工程指示 / 要求簡箋 ENGINEER INSTRUCTIONS (E.I.)

工程指示編號:	EI- 4467	修改版本:	C
	HK- 0539/22		
工程編號:	J 857	工程名稱:	啟德6552
收件人:	Maggie Lor (羅小姐)	發件人:	Yancy Chen
工程項目:	UP趟門 - 確認模圖(興發鋁材)	日期:	31/03/2022

內容: 現確認1款模圖, 封面1頁, 附件2頁, 共3頁.

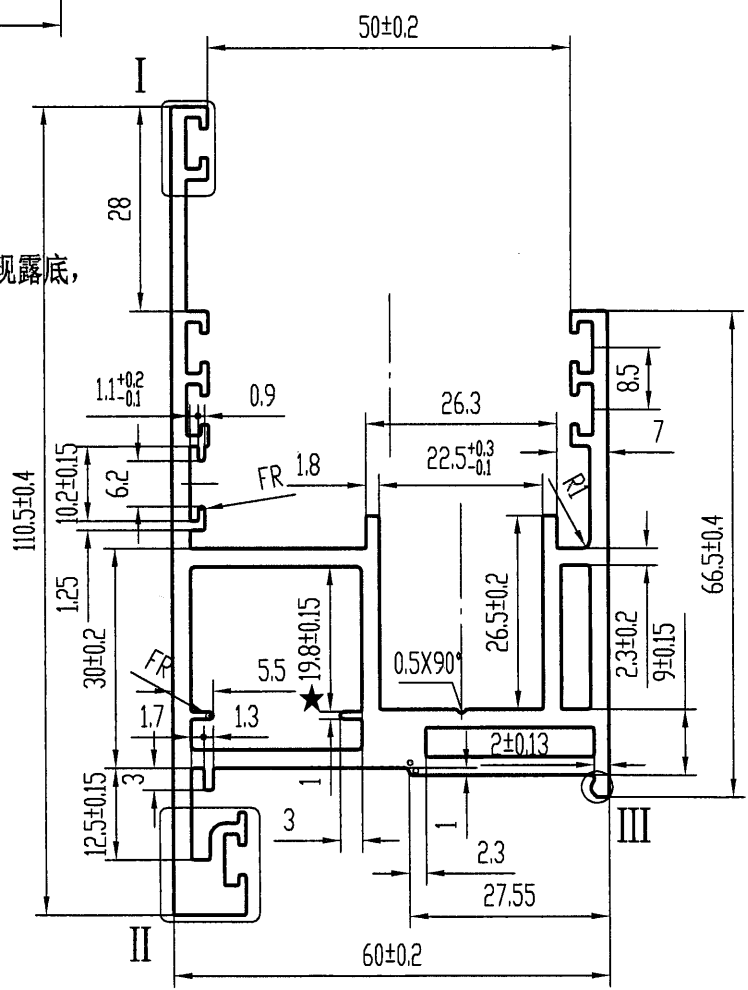
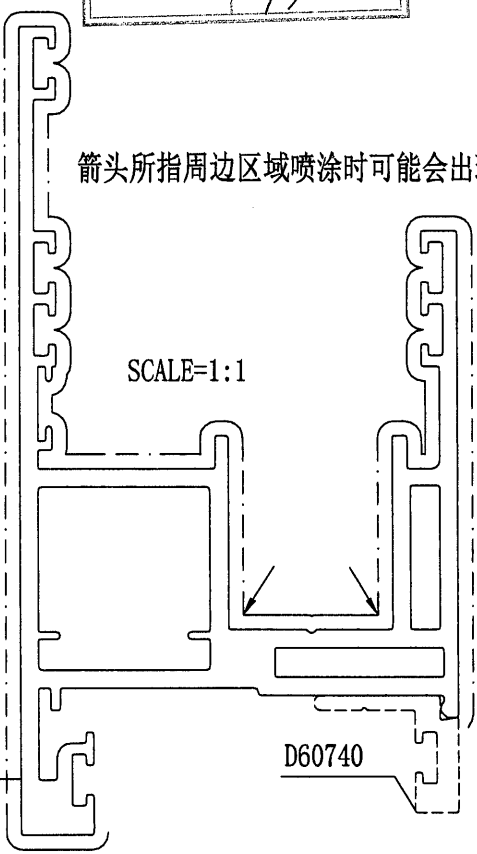
貴司 EI4467B 之批圖 X86270，我們發現標示之標準錯誤，正確應為 EN755-9，另外貴司未有簽署起影之提示，為免將來引起爭拗，我司圖紙已將提示標註在圖紙上，而不用貴司單獨簽名確認，如貴司簽圖則表示同意圖紙上之提示。請查收附件更新圖紙，及重新簽回確認，謝謝。

1. 装饰面为: _____
2. 基材验收标准按EN755-9执行
3. 表面处理是: 氟碳喷涂 ✓
4. 带“★”尺寸以实配为准
5. ◯=R0.5
6. 配角码: C04797
